MAS003715 RU 23-45

# Rapid Update 585 MC20 – Rear axle shaft replacement

**DATE:** AUGUST 3 2023

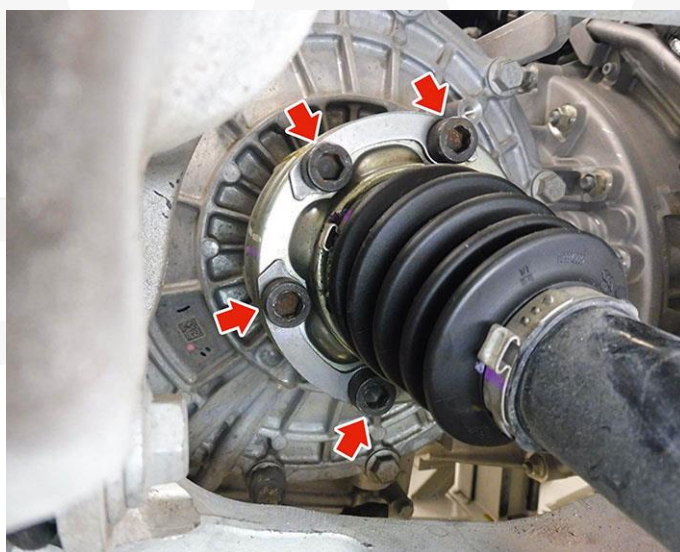
Certain Maserati MC20 and MC20 Cielo (M240) MY22 MY23 listed in MODISCS+ are involved in a Rapid Update to replace both rear axle shafts.

This replacement is necessary because the development of the project has led to an improvement of the component, guaranteeing better performance and a longer lifespan. Therefore, to offer our customers the best available technology, it has been decided to replace and update the vehicles that have already been sold.

1. Always check ModisCS+ to see if the vehicle is involved in this action and if it has not been previously performed.
2. Disconnect the battery by following the relative procedure in the workshop manual:
  - **8.20.001.0 BATTERY Disconnect-Connect Power Supply**
3. If thread lock has been used, refer to the following bolt-cleaning chart.
  - **00.AB.065 - CLEANING TABLE FOR THREADED ELEMENTS**
4. **Completely remove and replace** the left and right drive shafts following the instructions in the workshop manual. (**Section 03.10 - 1 GEARBOX HOUSINGS**)
  - **03.21.002 - COMPLETE RH HALF SHAFT - Removal/refitting or replacement**
  - **03.21.003 - COMPLETE LH HALF SHAFT - Removal/refitting or replacement**

Tightening torque of the axle shaft screws - 03.10.145	
<b>1. TIGHTENING TORQUE</b>	30N ·m (22.1 ft-lb)
<b>2. ANGLE</b>	90° (1.57 rads)
<b>3. CONTROL TORQUE</b>	45N ·m (33.2 ft-lb)
